MAX CRUISE MOD BLOCK DEFINITION

PROGRESS REPORT

Date: 12 March 1976

Issue 2 21st April 1976

FIG 2-2 MAX CRUISE LOGIC (AUTOTHROTTLE)

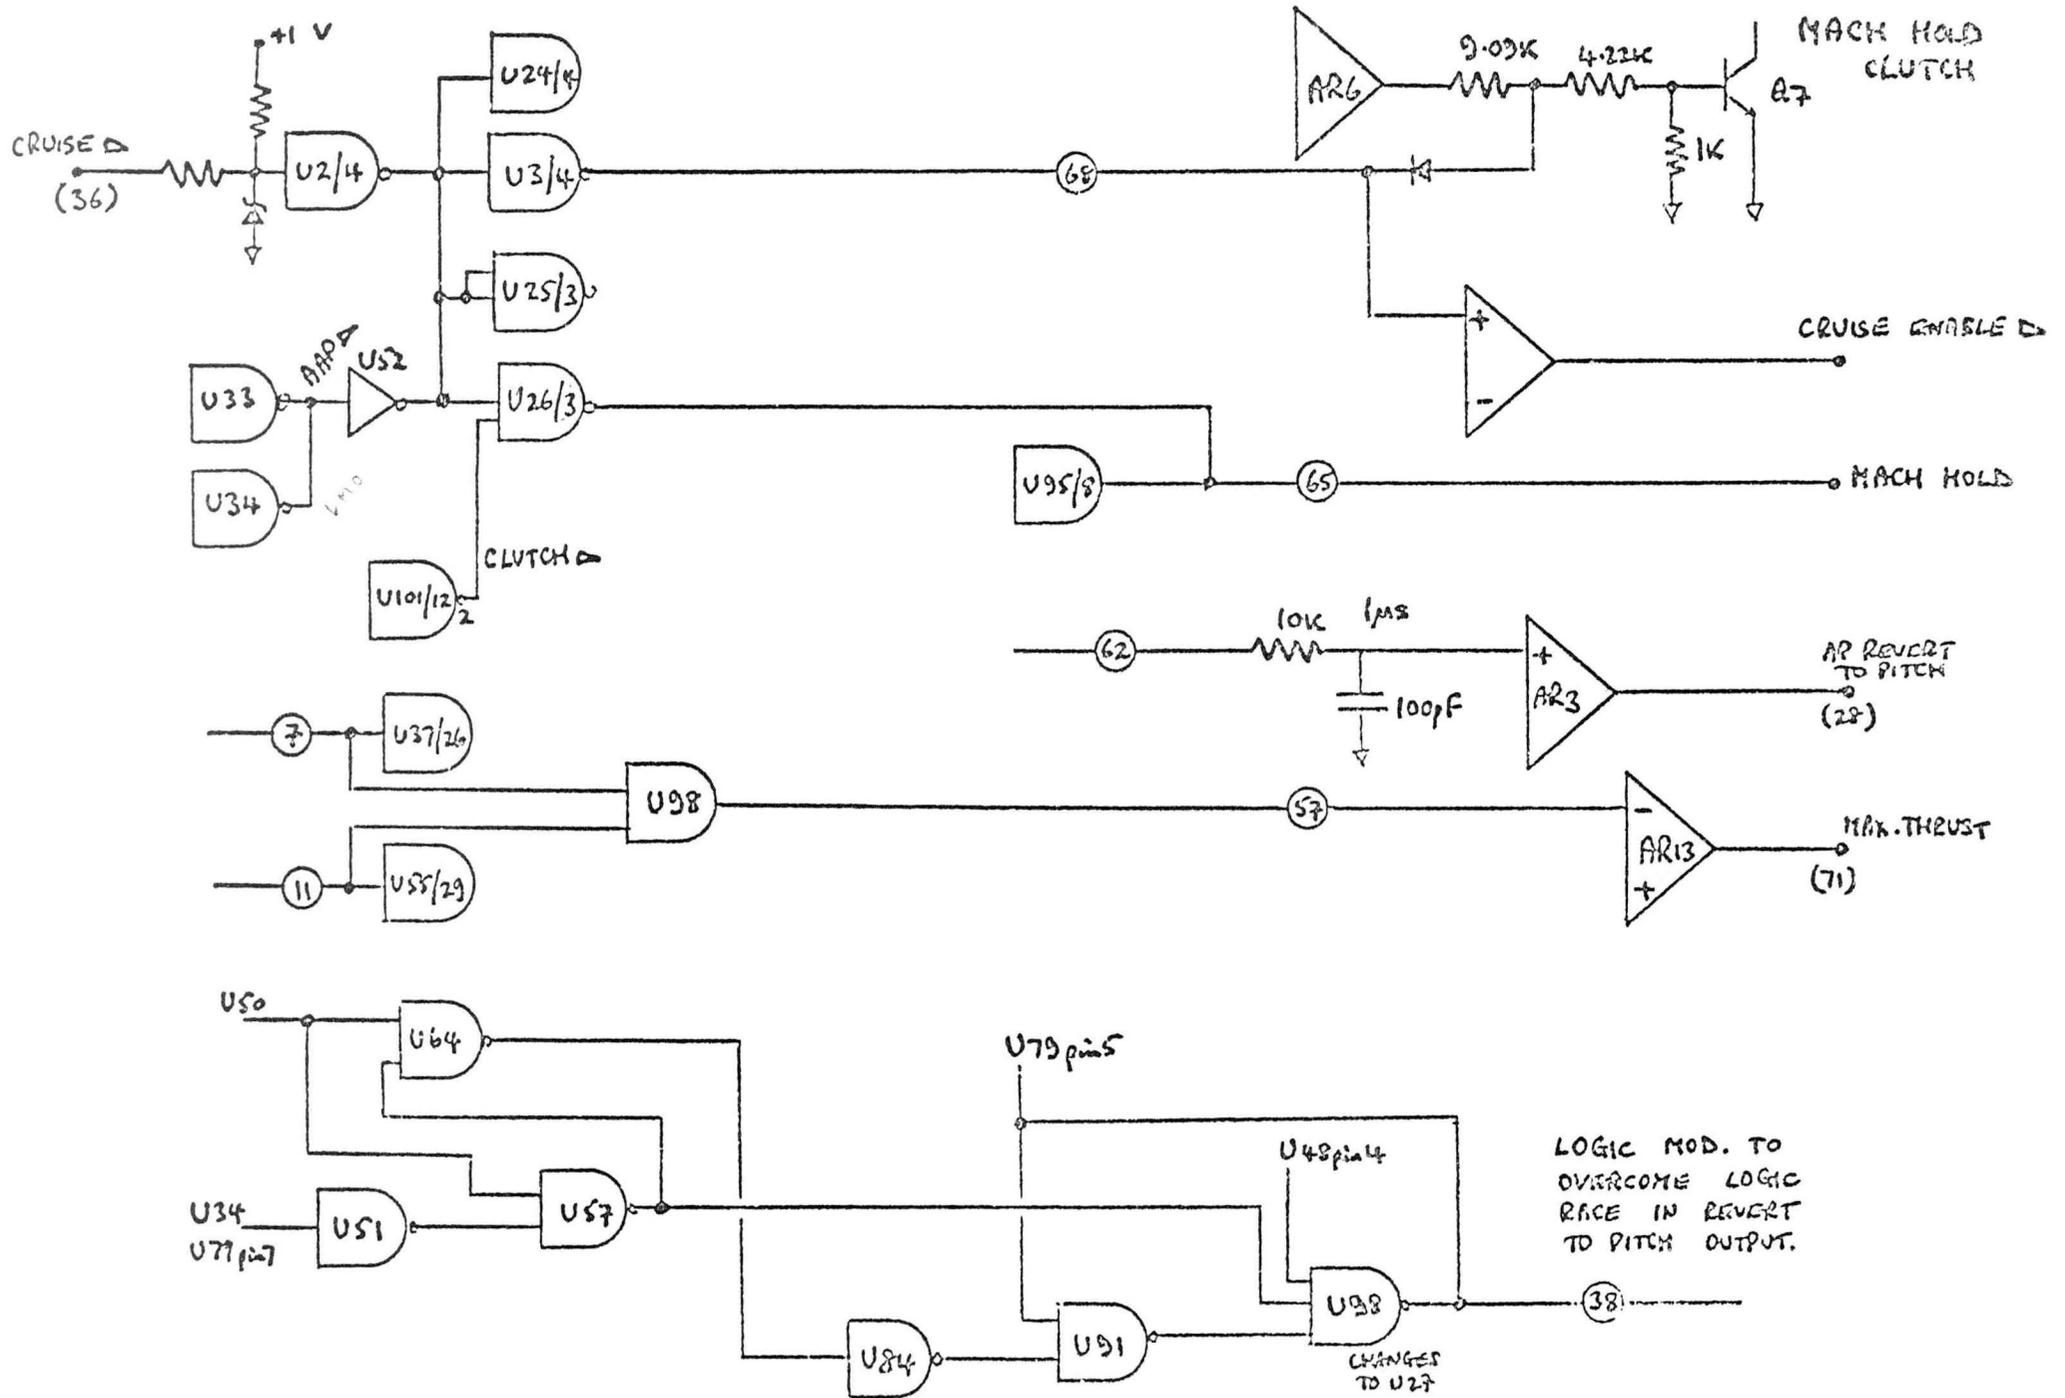
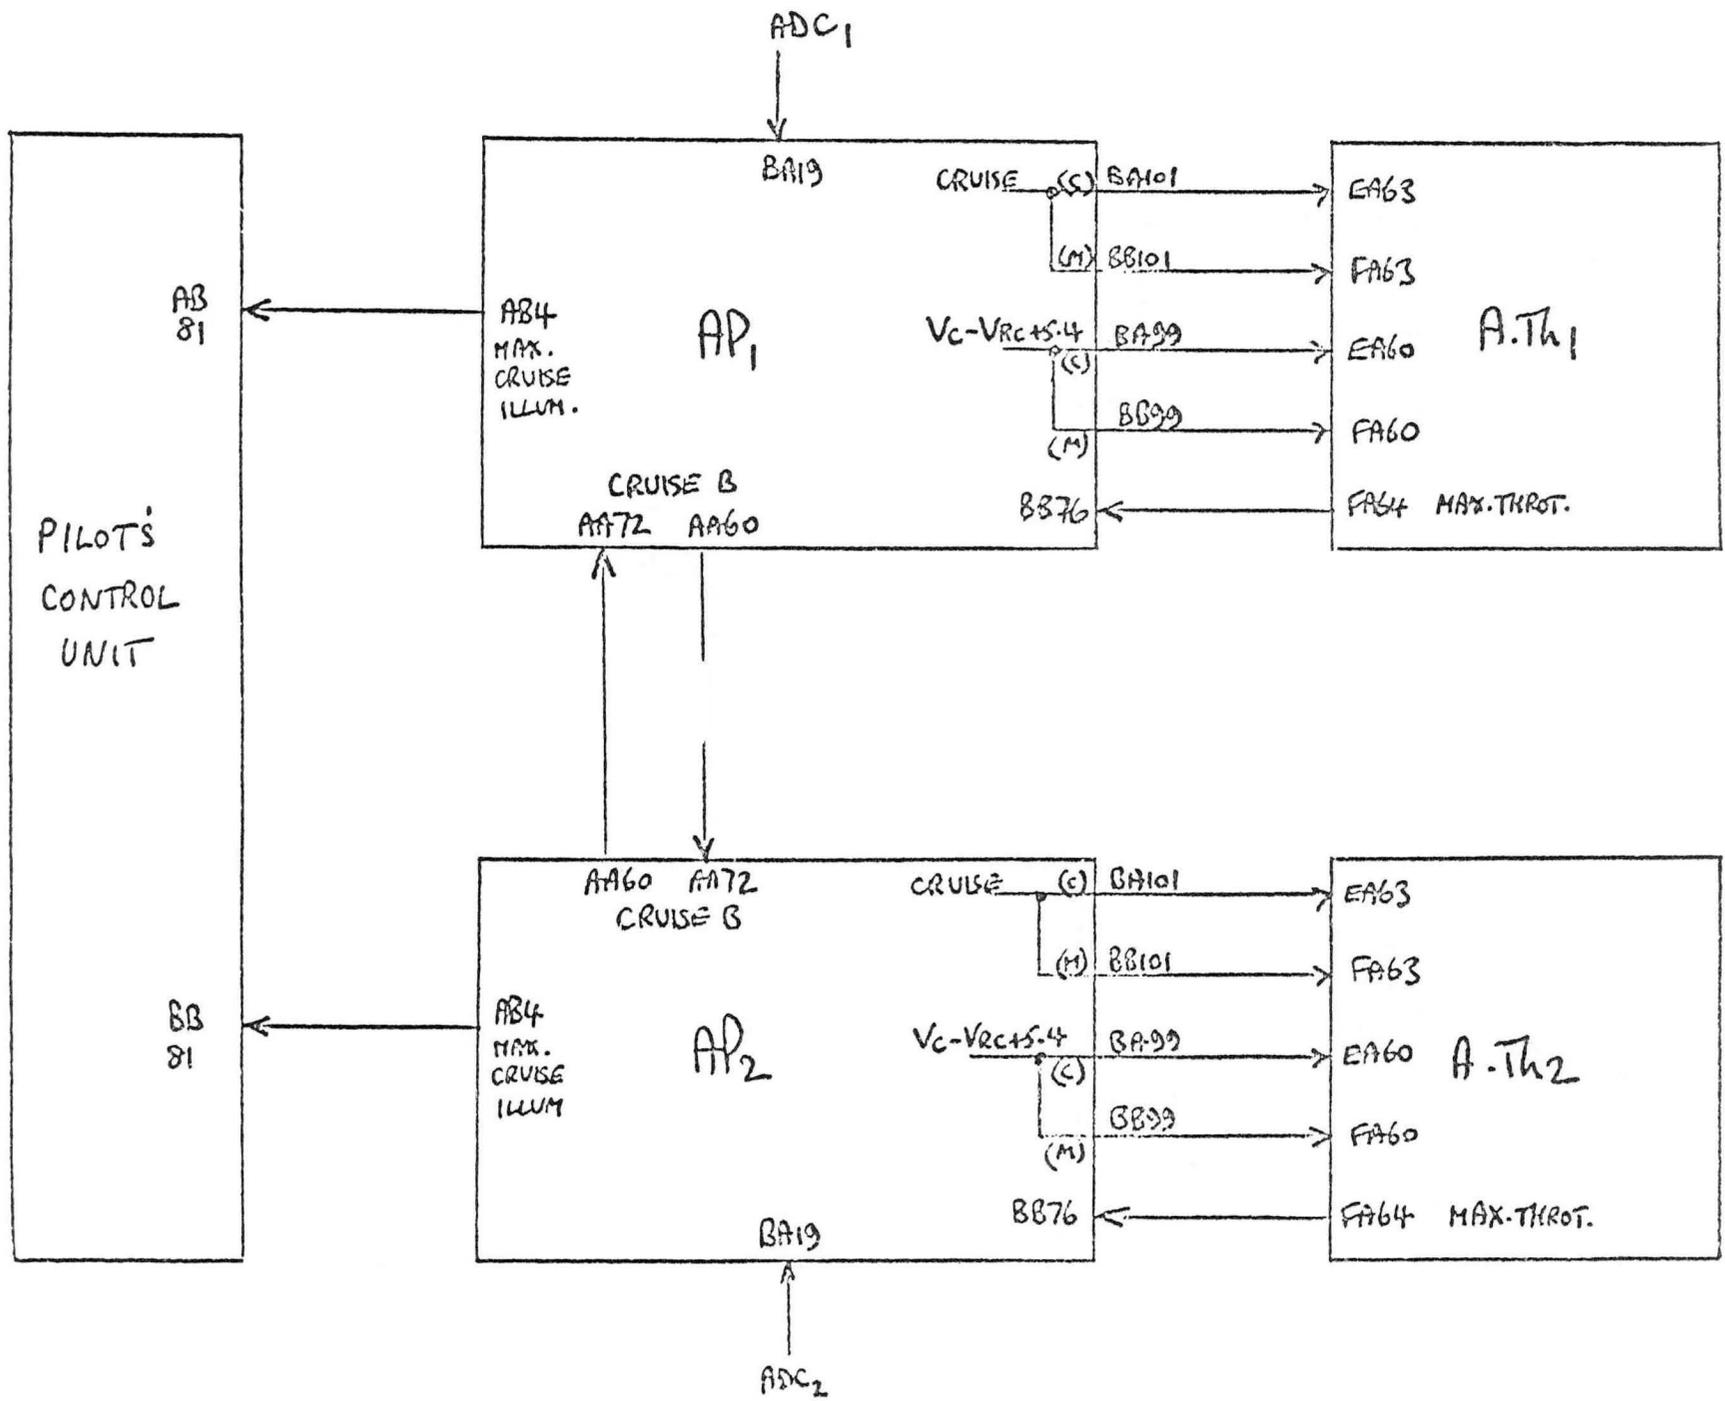
Fig. 2-2 illustrates the logic used to encode Mach Hold from the Vert. Nav. inputs, the inhibition of Mach Hold clutch and the generation of the signal 'Cruise enable' which ensures that a single failure in the APFD Cruise logic cannot invalidate the switching of the analogue computing in the Autothrottle. The Mach Hold output (used for mode illumination) is enabled by CRUISE or Autothrottle clutched and inhibited when in CRUISE with Autothrottle not clutched.

The inhibition of the Mach Hold clutch and the signal 'CRUISE enable' are generated from 'CRUISE' and 'AAP + VMO'. The Mach Hold clutch has to be inhibited during CRUISE to isolate the ADC from the A/Th computer since the Mach Hold switching functions remain active during CRUISE.

The generation of the logic signal 'Max thrust', for use in the APFD, is achieved when any of the throttle levers has reached the maximum position, as signalled from the throttle quadrant microswitches, and the appropriate

microswitch validation level switch has operated.

The 'AP revert to pitch' output contains a delay of approx.  $1 \mu\text{sec}$  - this is necessary for the case when the Autopilot is selected into another speed mode e.g. Mach Hold. When this occurs, CRUISE disappears followed by AAP+ VMO (with delay) and the Autothrottle will disconnect and the engage switch will start to drop. This will generate 'AP revert to pitch' until the engage switch has fully dropped - by re-organising the 'Engage to computing' logic within the Autothrottle and incorporating a small delay in the 'AP revert to pitch' output the logic signal can be prevented from affecting the APFD.

A - FIG 5-1 AFCS WIRING

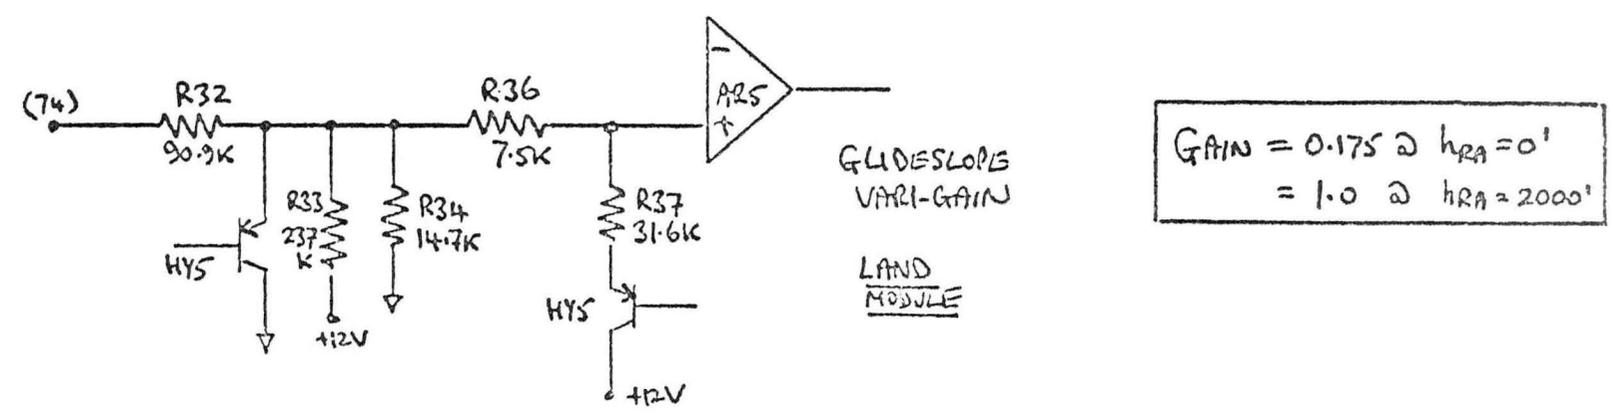
The existing 'Max Op Soft' Tellite switch is changed to an indicator type 3755-00004 with associated control unit internal wiring changes. See Fig. 5.1 for associated AFCS wiring changes.

The changes to the aircraft wiring associated with all the fore-going modifications are illustrated in Fig. 5-1.

B-FIG 1-1 NEW GLIDE CONTROL LAW

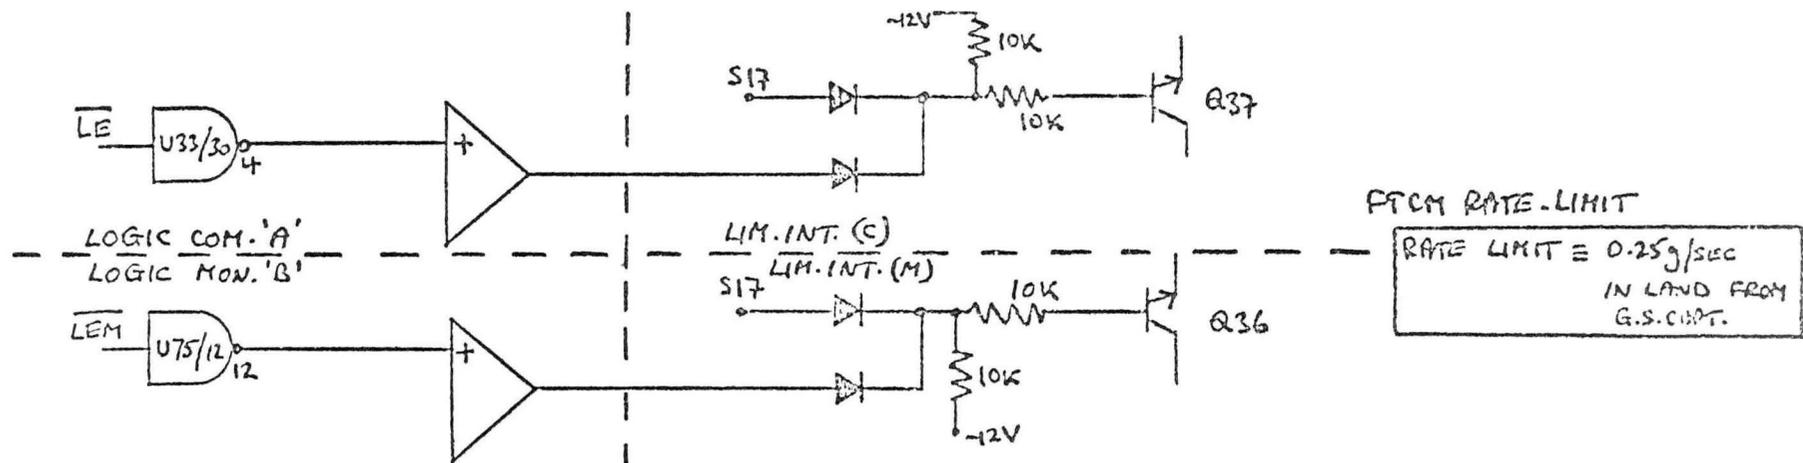
1.1. New Glide Control Law (DCR 11004 (a, b, c) ) Fig 1-1 refers

The change in gain of the Glide variable gain is achieved by component changes only.

The rate limit change is effected by the generation of a new logic switching function (Land engage) which operates through a diode-or function on the rate limit switch which at present exists for Go-Around.

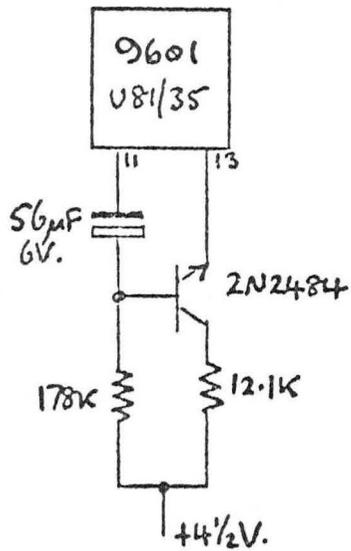
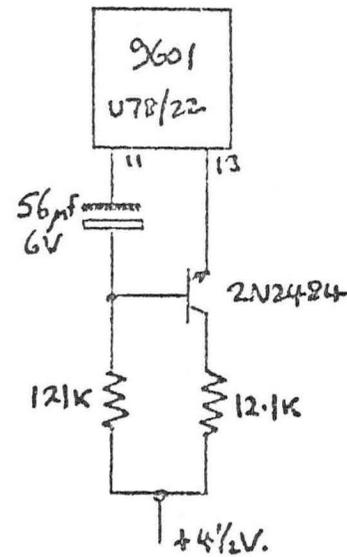
1.2. Increased delay on "on Beam" delay (DCR 11004(d) )

This is to ensure that a genuine Glide slope capture is enabled only when the conditions for capture (sign sensors in the correct sense and G/S receiver failure warning healthy) have existed for 3 seconds. This ensures that a transient appearance and disappearance of the Glide slope receiver failure warning within 3 seconds cannot enable a false capture. This is achieved by the increasing of the time constant of the 'On Beam' delay to 3 secs - this requires the use of a transistor driver. Fig. 1-2 refers.

TIME DELAY  
= 3 SECS.

TIME DELAY  
= 2 SECS.

B-FIG. 1-3 GO-AROUND LOGIC

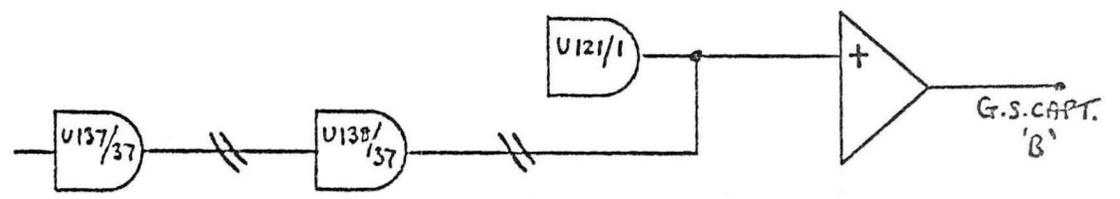
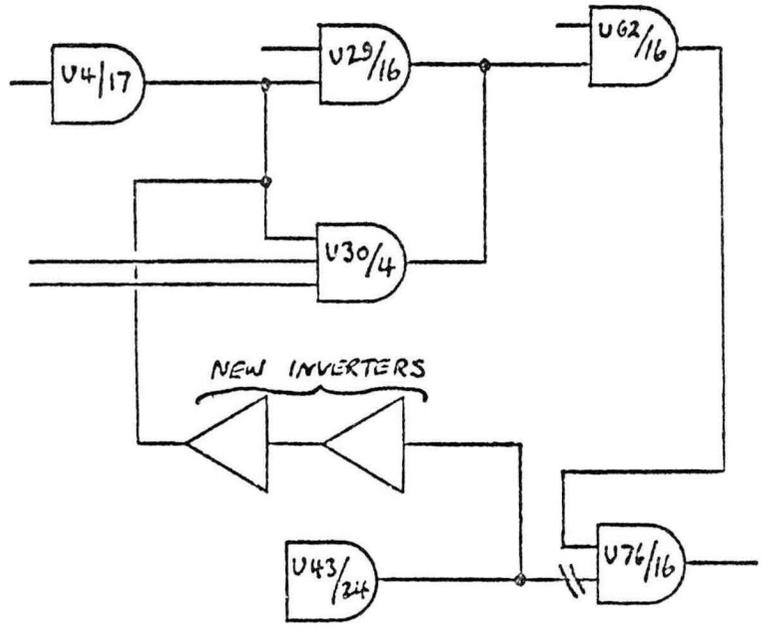
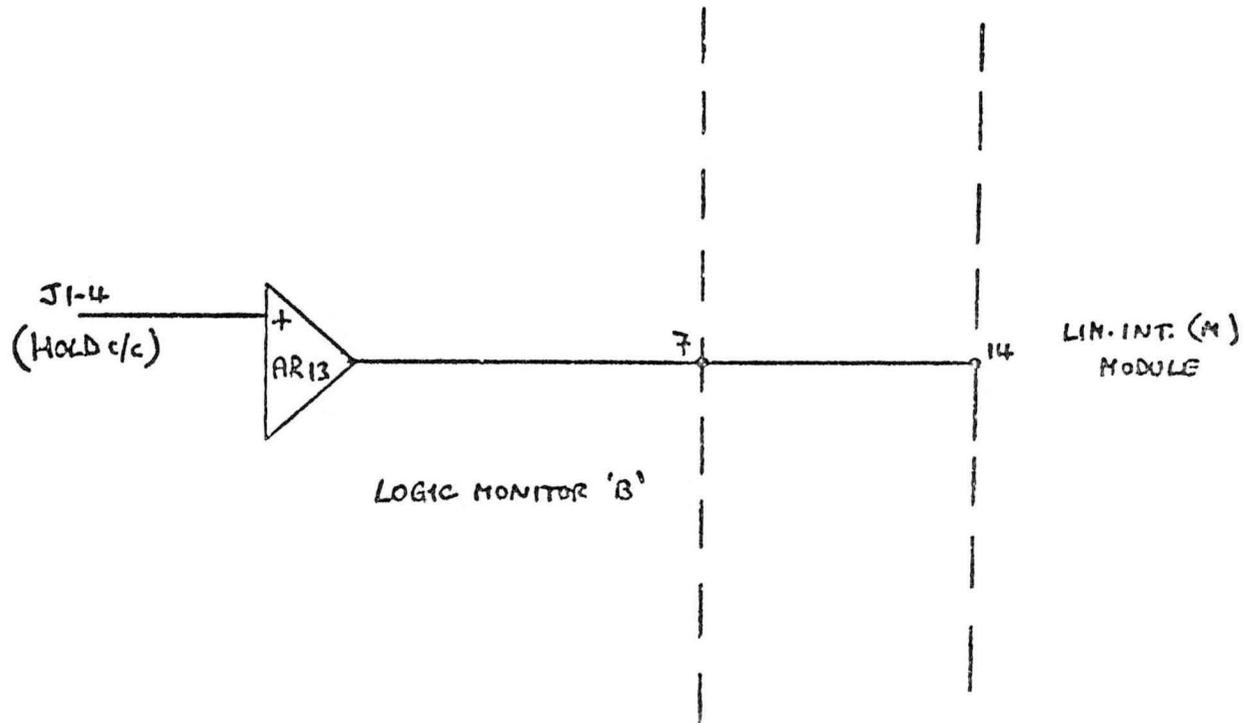
1.3. Go-Around logic (Fig 1-5 refers)

It was noted in SNIA telex no. 12 of 9. 3. 76 that the cancellation of Go-around mode (when previously in Glide mode) frequently resulted in the Pitch axis reverting to Glide mode when Heading Hold was selected.

Investigation showed that when Go-around was selected an inhibit was placed on the Glideslope capture 'A' outputs but that the Glideslope capture 'B' outputs were forced healthy (this was to ensure that selection of Go-around did not result in the encoding of Pitch mode). This meant that when Heading Hold was selected (to terminate Go-around) the conditions for encoding external mode were (transiently) still extant and Glide Capture recurred.

The proposed solution changes the logic in two areas on the Logic Command A module -

- to remove the enabling condition on the Glideslope capture B output when in Go-around (This removes the mechanism which results in Glide mode the end of Go-around).
- to remove the system engagement condition which was used to latch the Glide capture signal (This overcomes the problem of Pitch mode being

encoded at the start of Go-around the logic for which was removed in the modification to the logic on the Glideslope capture 'B' output)

The Logic Monitor B module has been modified in accordance with the first part of the logic changes above. The second part of the command logic modification is not necessary in the monitor logic since all mode encoding is achieved in the command logic only.

These modifications ensure that selection of Heading Hold will cancel Go-around (when in Glide or Land mode) and cause Pitch and Heading Hold mode selection.

B- FIG. 2-1 GLIDESLOPE & AUTOLAND WARNING INHIBITS

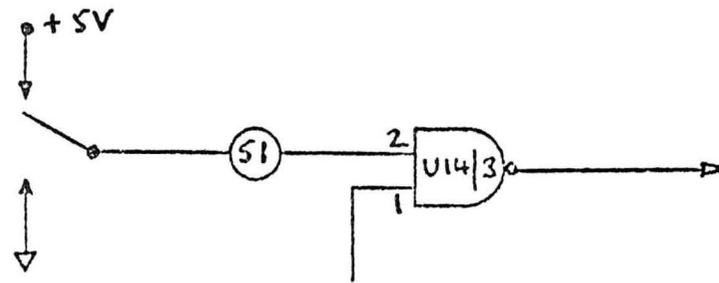
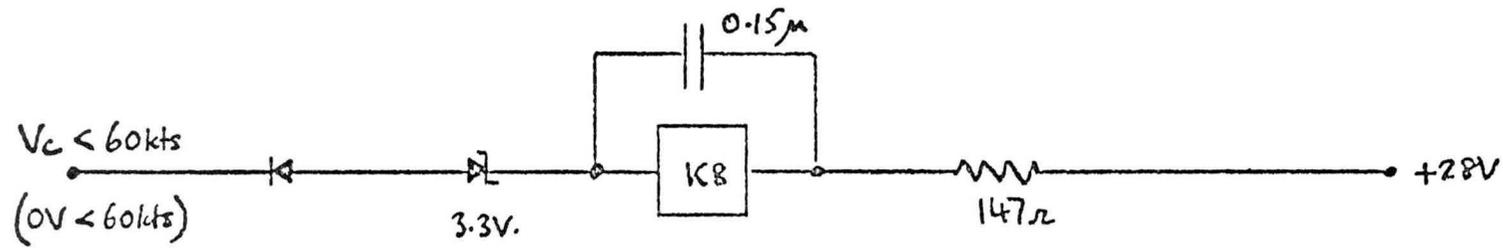
The introduction of the new 100' level switch is used to inhibit glide slope deviation warnings and the resulting Autoland warning.

The 75' interlock from the APFD (pitch) computer is used to inhibit

- the AP disconnect resulting from a single GS receiver failure
- the Autoland and flashing boundary exceed bars resulting from a GS transmitter failure.

The new 100' level switch is fitted on the Radio logic assembly (monitor) module.
